Flood Risk Review

Gregory's Farm Development P1543/14/FUL

Brockweir

Hewelsfield and Brockweir Parish Council

Figure 2-1 – Proposed Development

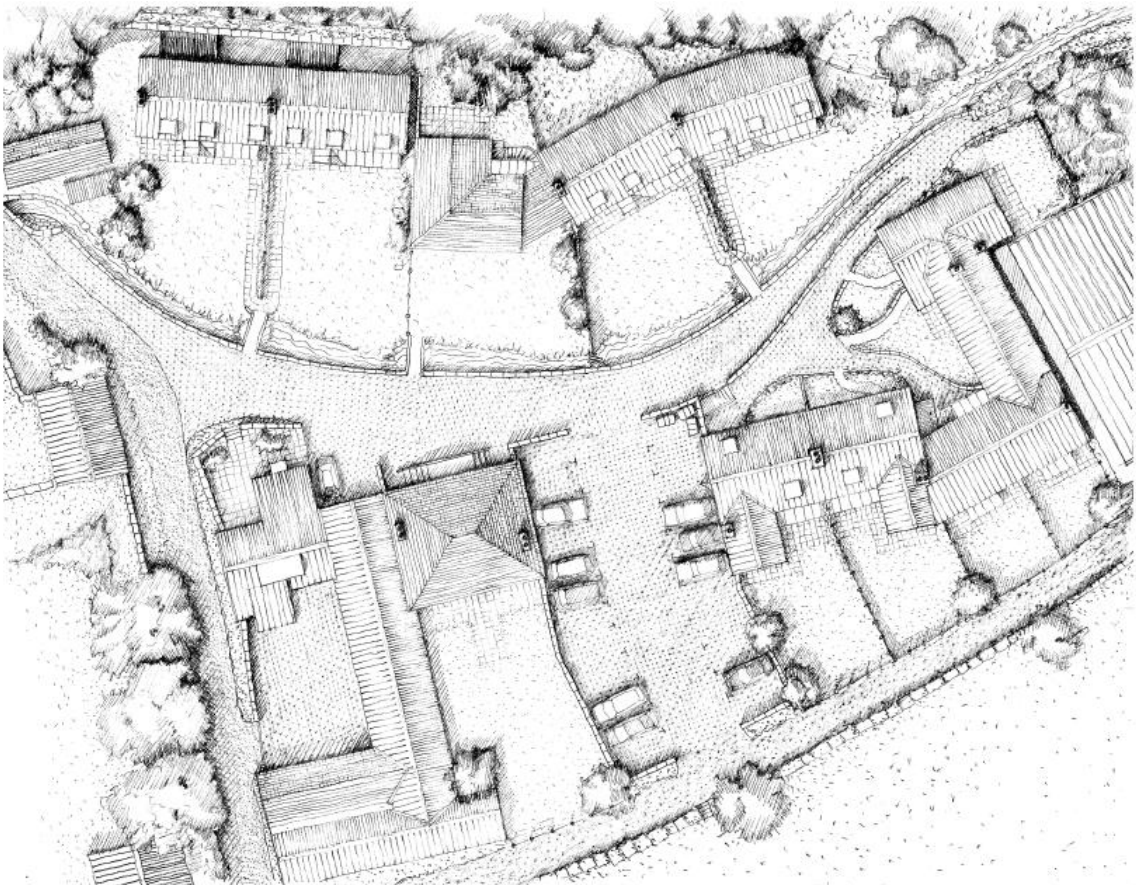
Deculverting (daylighting) this section of watercourse provides an opportunity to restore a more 'natural' stream within diverse in-channel and bankside habitats that link with woodlands upstream. It may also provide an aesthetically pleasing watercourse for the local public. At the moment the designed scheme will provide none of these benefits and will only make the situation worse.

Simply excavating the watercourse and removing the concrete would produce a far from natural channel.

The design of the river channel should be based on the historical layout, fluvio-geomorphology, flooding considerations (i.e. capacity to discharge the 1 in 100 year plus climate change event) and proposed use of the site for residential purposes. The design should also take into account any existing and future land drainage connections. At the moment the designed scheme is not based on any of these factors.

The proposed channel should be adequately sized to discharge the 1 in 100 year (plus climate change) event therefore, the capacity of the open channel should be a minimum of $4.28\text{m}^3/\text{s}$. The channel has been sized assuming normal flow conditions and also from the size of the bridge under the downstream road. The size of the channel is based on the cross sectional area of the watercourse (e.g. m^2) which is incorrect. It is feasible for example to have a very wide and shallow channel which can discharge a totally different volume of water compared to a very deep and narrow channel.

The channel should be sized so that it can discharge the flood flows generated by the catchment taking into account slope, roughness coefficient (e.g. manning's n), water velocities, climate change etc. The new channel should vary in bank slope and bed width, and bed slope. At the moment the designed scheme has not been designed accordingly.

When considering this type of scheme, where the stream flows through culverts/bridges, it is good practice to build in 'sediment traps'. These can take many forms and do not have to resemble deep holes or even be maintained once the site has stabilised. At the moment the designed scheme has not been designed accordingly.

A 'buffer zone' between the open channel and any permanent structures such houses, fences etc. should be maintained to allow for access and maintenance to the open channel as well as providing additional flood storage. This is also a requirement of the

Environment Agency, Forest of Dean District Council and Lead Local Flood Authority. At the moment the designed scheme has not been designed accordingly.

If a storm that exceeds the design events occurs flooding of properties will occur. The proposed channel is located in close proximity to the proposed dwellings causing these to flood and the watercourse will also cause flooding of properties located downstream.

The positioning of the watercourse appears to put the liability on future land owners along its entire length due to the close proximity to the proposed dwellings. The proposed open watercourse will also have to be wide and deep to convey the flood flows that area generated within the catchment this will pose health and safety issues if the site is used for residential uses with children and animals etc. No design of the watercourse has been undertaken but due to the large size of the watercourse required it is highly likely that

the watercourse will have to be concrete lined which will pose its own issues for flood risk, ecology, aesthetics, pollution, health and safety etc.

No detailed assessment of access and egress from the site during a flood event has been undertaken. A number of the houses can only be assessed by footbridges therefore; it will not be safe to cross the watercourse during a flood event via these footbridges. It is likely that the footbridges will be washed away during a flood event. NPPF, Environment Agency guidance and the Forest of Dean District Council SFRA requires that safe access and egress can be maintained during the 1 in 100 year (plus climate change) event. Based on the current proposed design it is considered highly unlikely that safe access and egress can be maintained during the 1 in 100 year (plus climate change) event.
